Contract Number 8715	Contract Title Keechelus Dam to Stampede Pass Phase 2A	Federal Aid Number State Project
Change Order Number 7	Change Description VECP No. 1 Staging Revision	Date Nov 20, 2015
Region South Central Region	Project Engineer Scott Golbek	Phone Number 509-577-1810
Prime Contractor / Design-Builder Guy F. Atkinson Construction

CONTRACT NO: 008715 FEDERAL AID NO:
CONTRACT TITLE: I-90, KEECHELUS DAM TO STAMPEDE PASS PHASE 2A- ADD
CHANGE ORDER NO: 7 VECP NO. 1 STAGING REVISION

This change order incorporates a Value Engineering Change Proposal (VECP) in accordance with Section 1-04.2(2) into the Contract. Work will consist of a realignment of the DE1 Line, involving grading, surfacing and HMA paving. Revisions to the Order of Work as outlined in the Special Provisions are also made as part of this change order.

I-90	Plot 1
KEECHELUS DAM TO STAMPEDE PASS PHASE	PLAN REF NO
2A - ADD LANES/BUILD WILDLIFE BRIDGES	TR1-1
TEMP. ROADWAY SECTIONS - STAGE 1	SHEET 35 OF 788 SHEETS

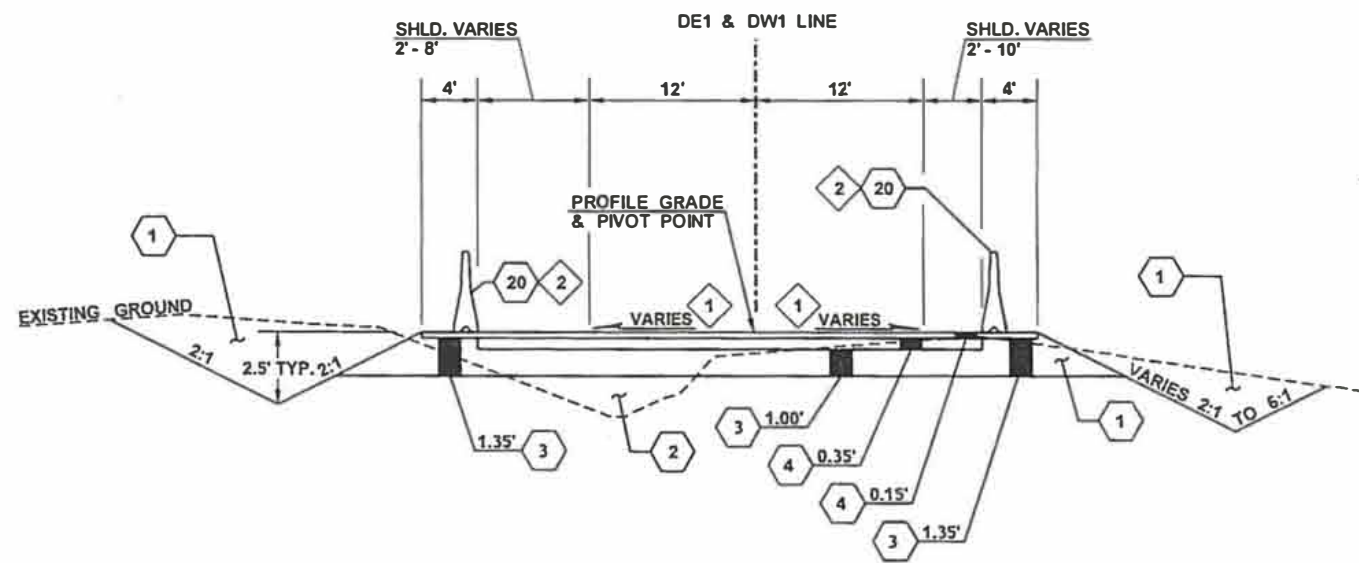
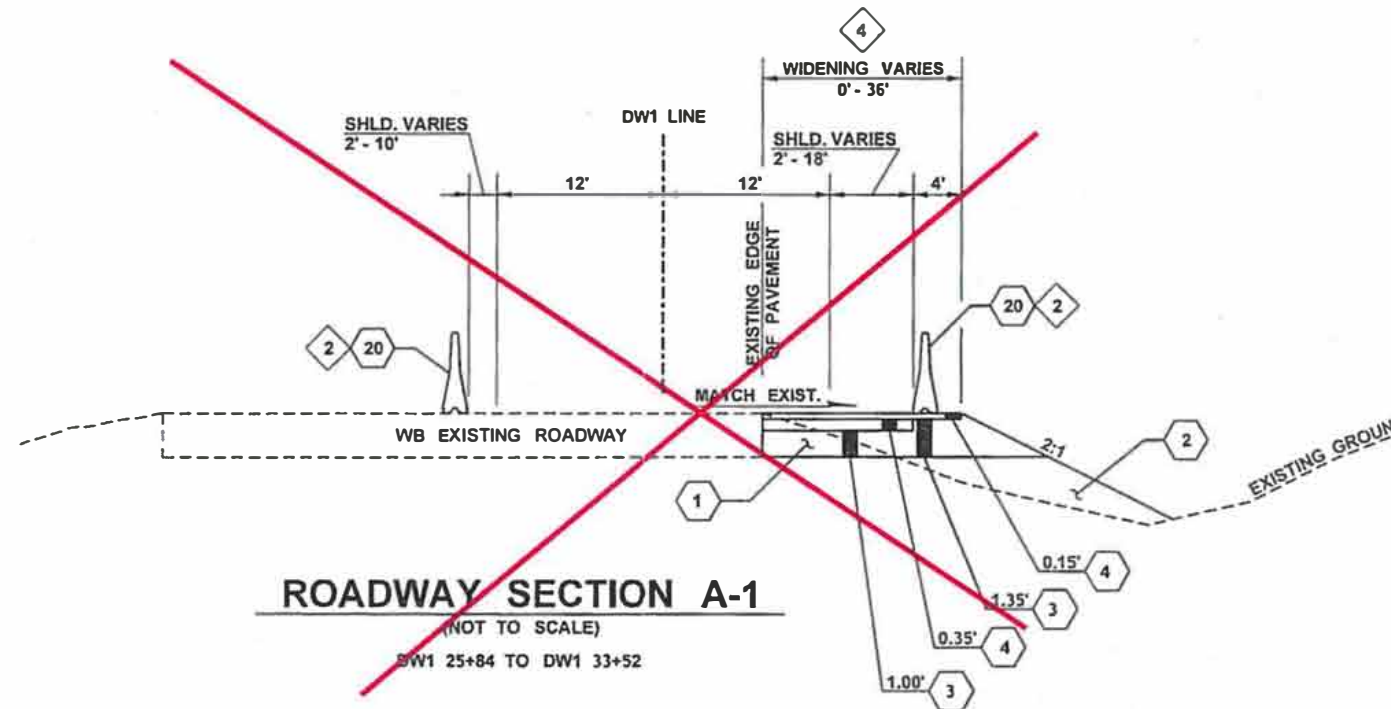
~~DW1 33+52 TO DW1 37+00~~
 DE1 84+36 TO DE1 104+75
 DW1 120+26 TO DW1 121+03

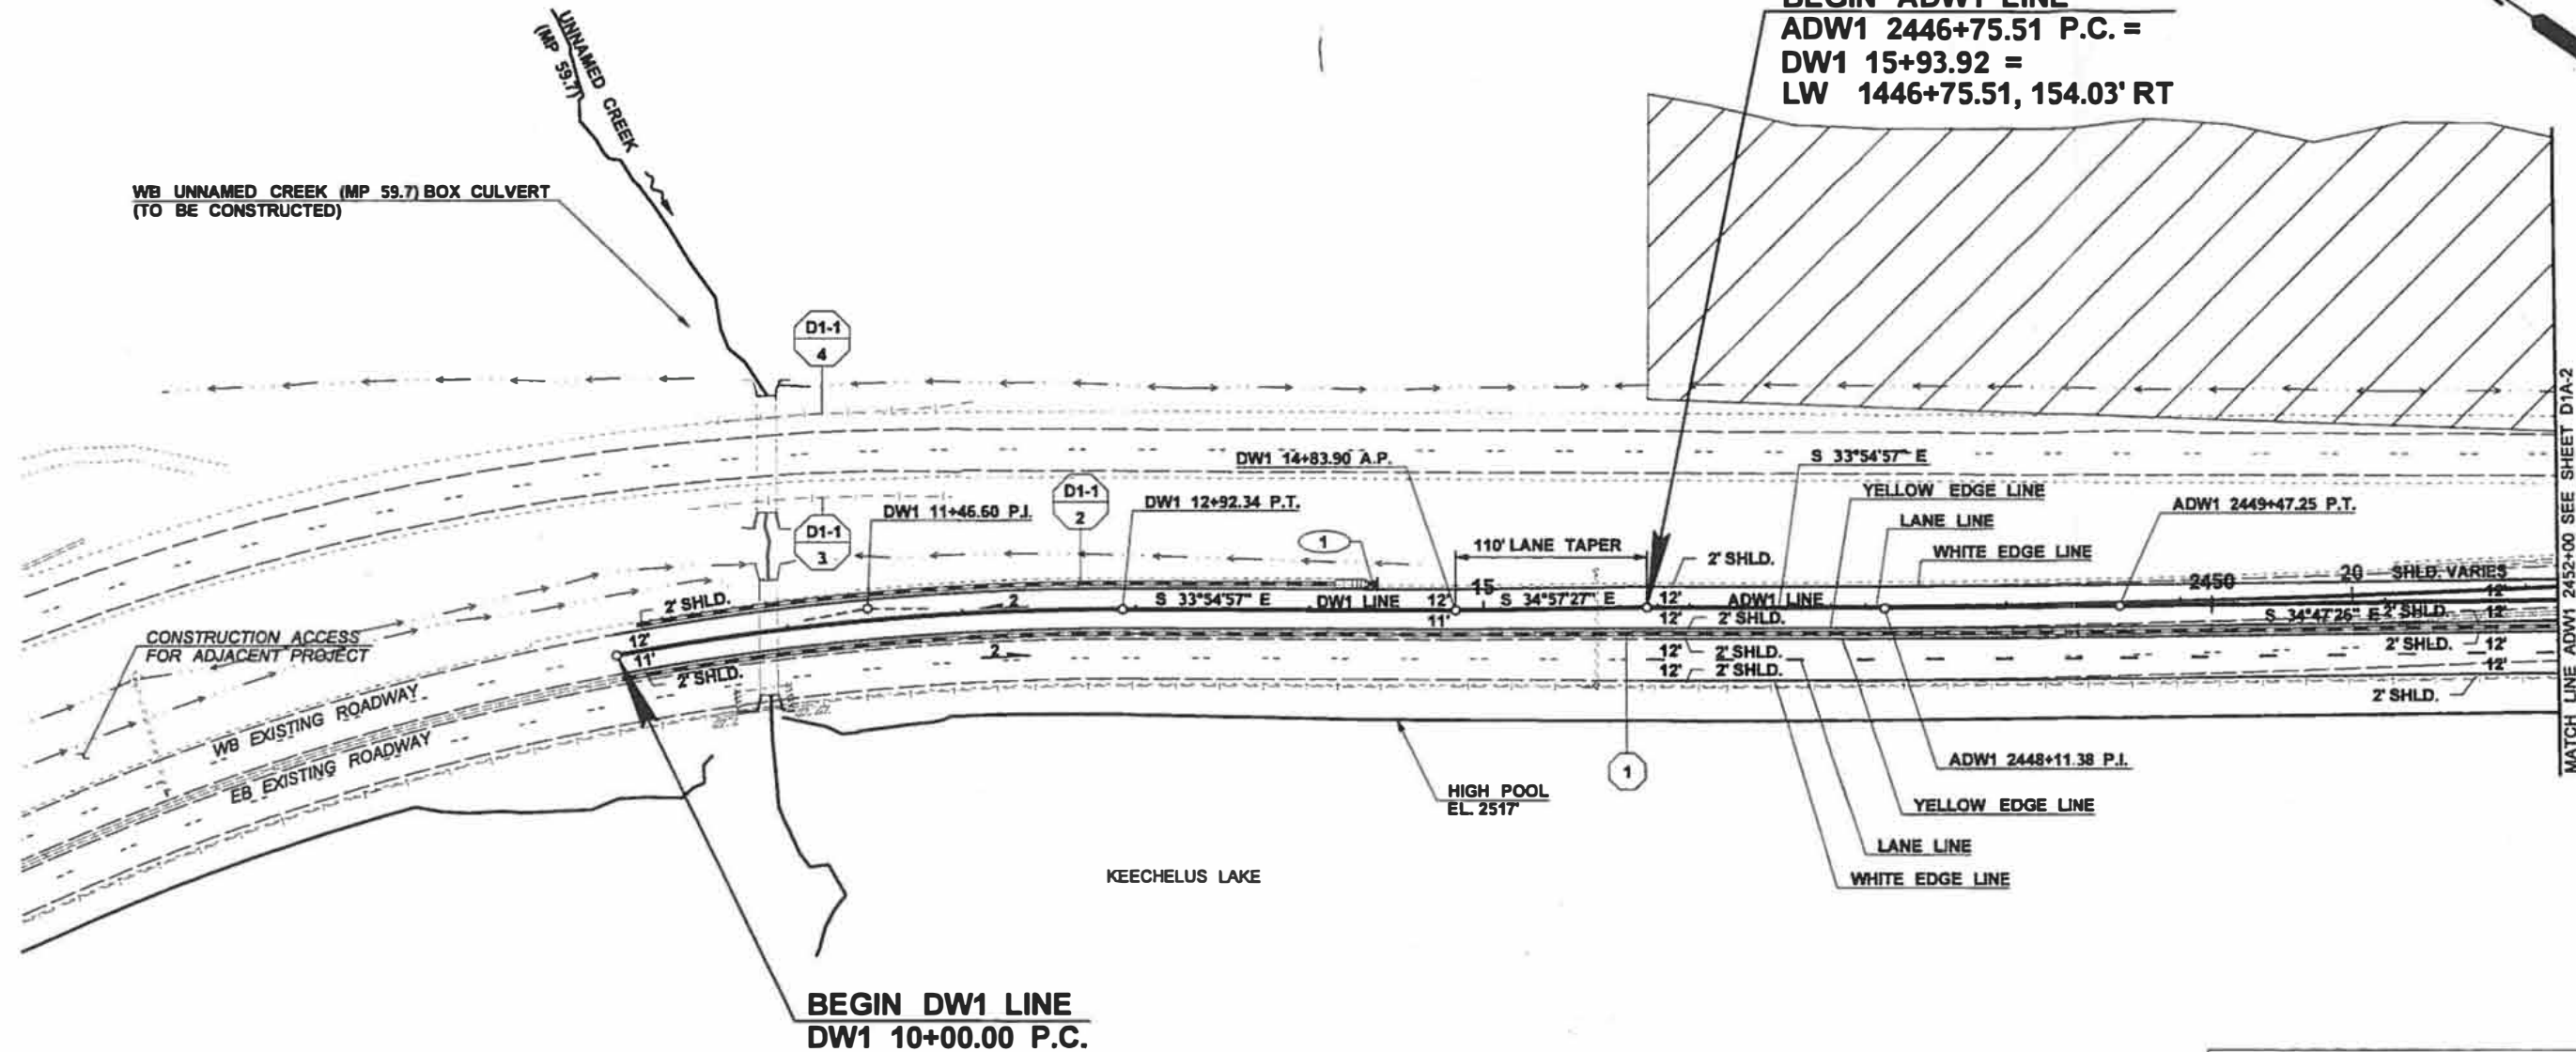
- Provide plans to realign the westerly end of the DE1 line which will provide access for the Contractor to work on the entire westbound alignment.
- Reduce the number of construction stages from 5 to 2.
- Reduced quantities will be realized due to the reduced staging.
- Overall cost savings to the Contract that will be shared between Atkinson Construction and WSDOT.
